RE: TRACT 3 PLAT OF TRACTS 1 THRU 4 COORS VILLAGE BEING A REPLAT OF TRACT A-1-A UNIVERSITY OF ALBUQUERQUE URBAN CENTER CONT 13.5436 AC, Albuquerque, Bernalillo County, New Mexico

**Project #2018-001584 (1000032, 1007282, 1001624)**  
**SI-2018-00221 – Site Plan for Building Permit**  
**RZ-2018-00047 – Zone Map Amendment (Zone Change)**

Re: Presbyterian  
Southwest Corner of Coors and Western Trail NW (TRACT 3 PLAT OF TRACTS 1 THRU 4  
COORS VILLAGE BEING A REPLAT OF TRACT A-1-A UNIVERSITY OF ALBUQUERQUE  
URBAN CENTER CONT 13.5436 AC, Albuquerque, Bernalillo County, New Mexico)  
Albuquerque, New Mexico  
Request for Site Development Plan for Building Permit

**CONDITIONS OF APPROVAL, Site Development Plan for Building Permit  
Project # 2018-001584, Case # SI-2018-00221**

DRAWN BY: ARS  
REVIEWED BY: ARS  
DATE: 12/27/2018  
PROJECT NO.: 18-0103.001  
DRAWING NAME: FIRE 1 PLAN

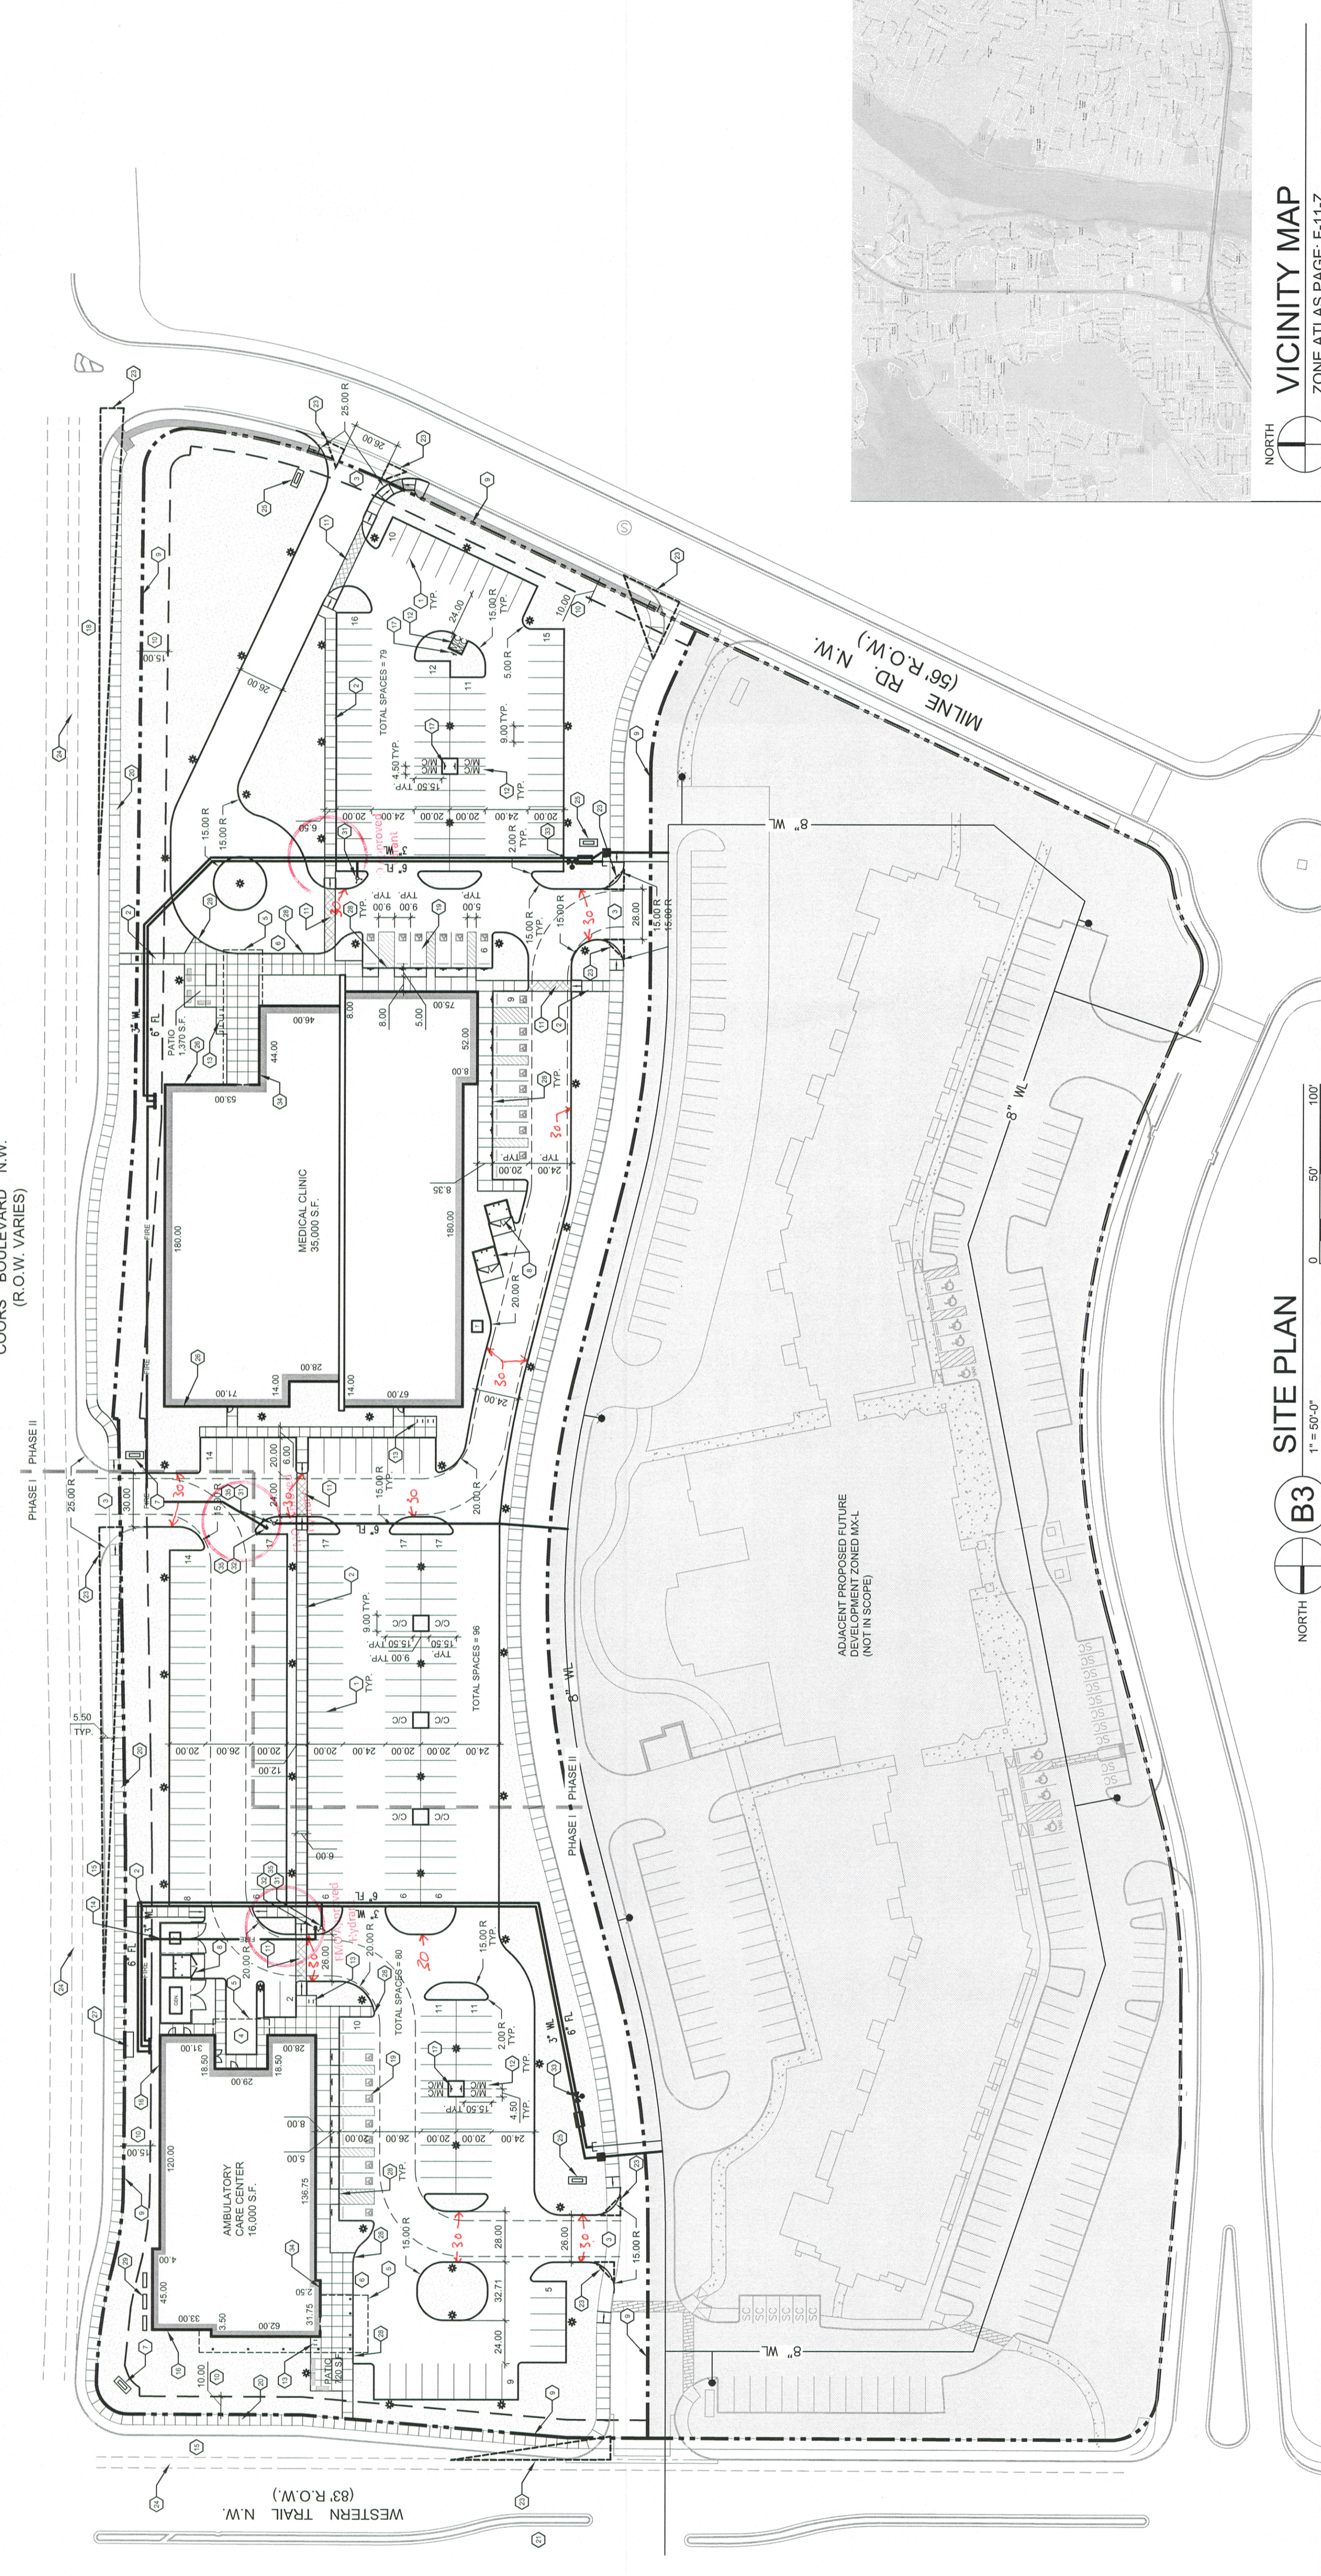
- i. Request shall include a City Fire Marshal approved Fire 1 Plan and a zone map showing the site location.
8. Conditions from Public Service Company of New Mexico

Response: A request for a revised water availability statement has been filed including the approved Fire 1 Plan.

**SITE PLAN**

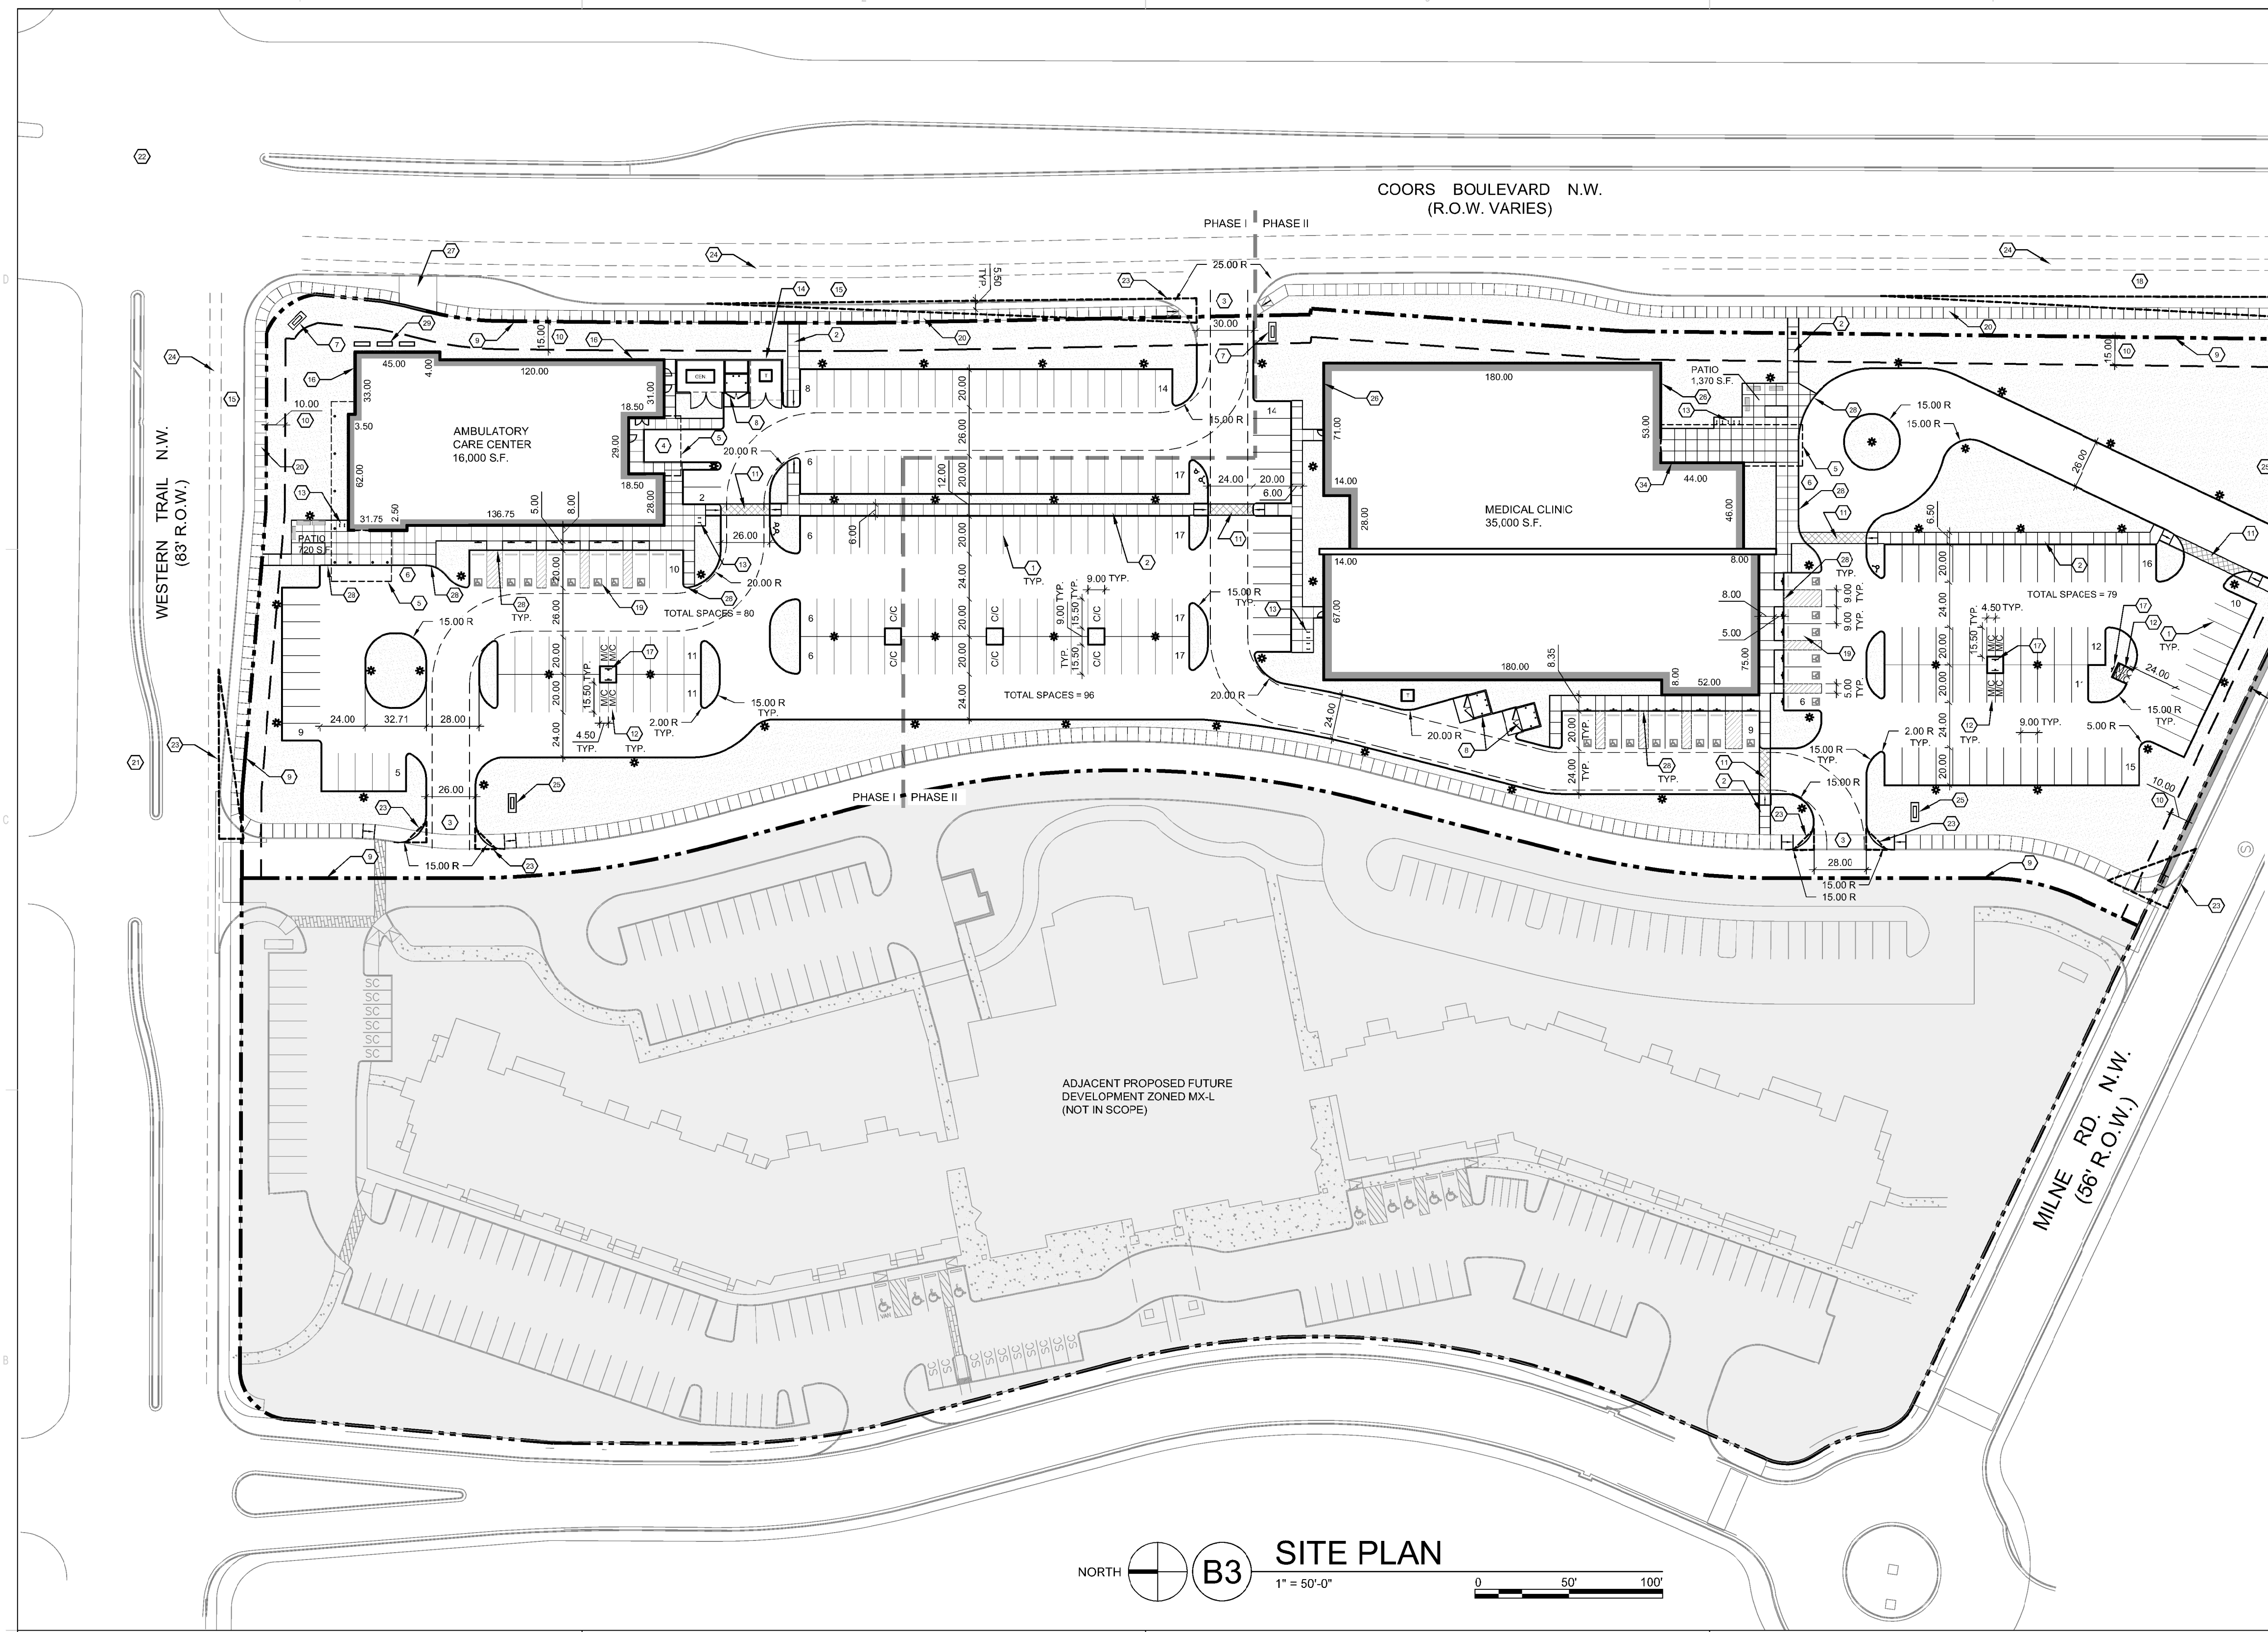
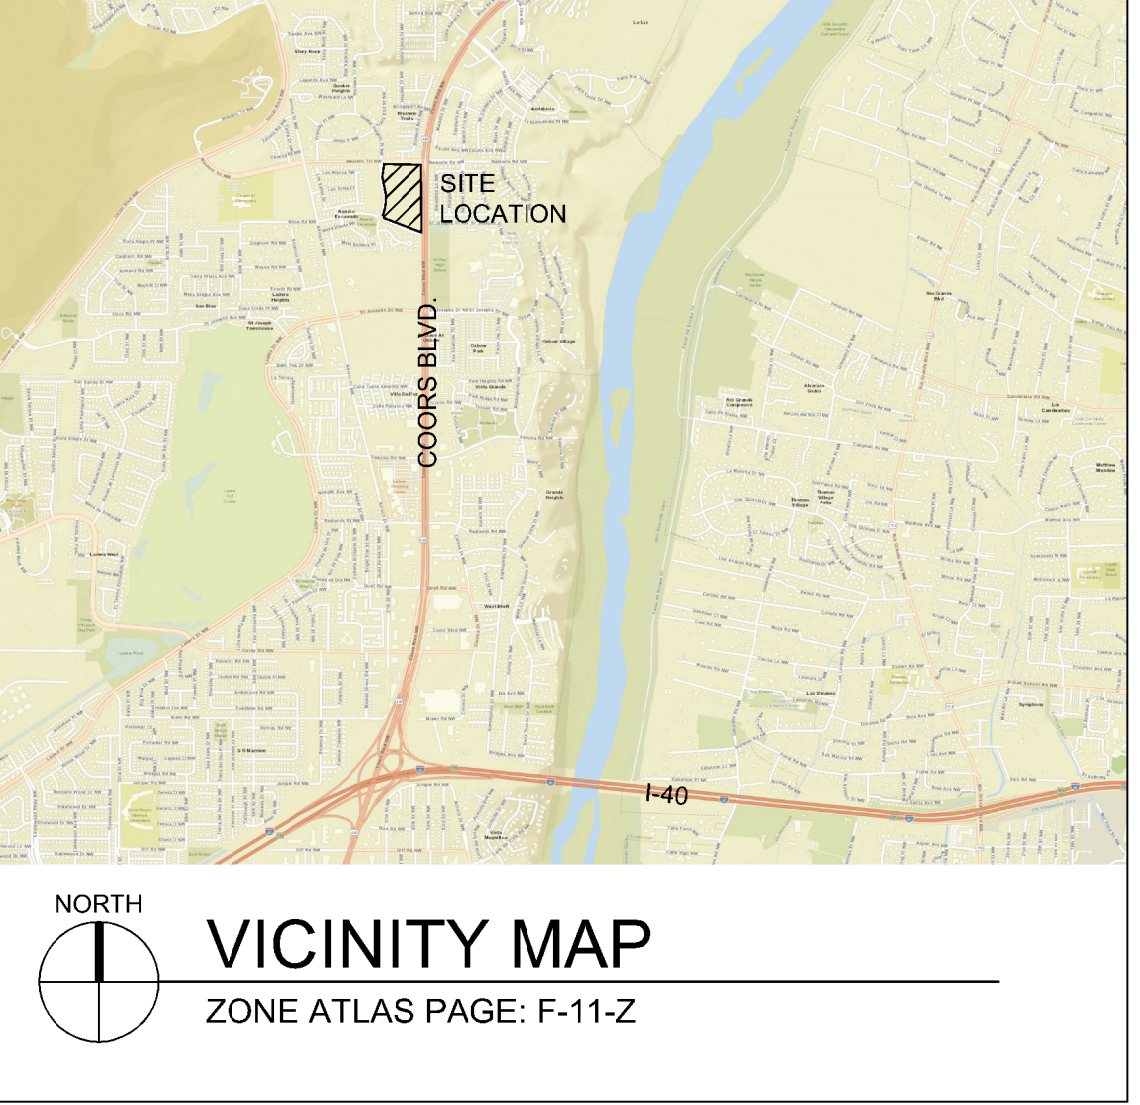
2. Prior to application submittal to the DRB, the applicant shall meet with the staff planner to ensure that all conditions of approval are met.
3. Parking requirement of 175 spaces for the medical clinic shall be provided as only 174 are currently shown.

Response: 175 parking spaces have been provided in the current site plan.
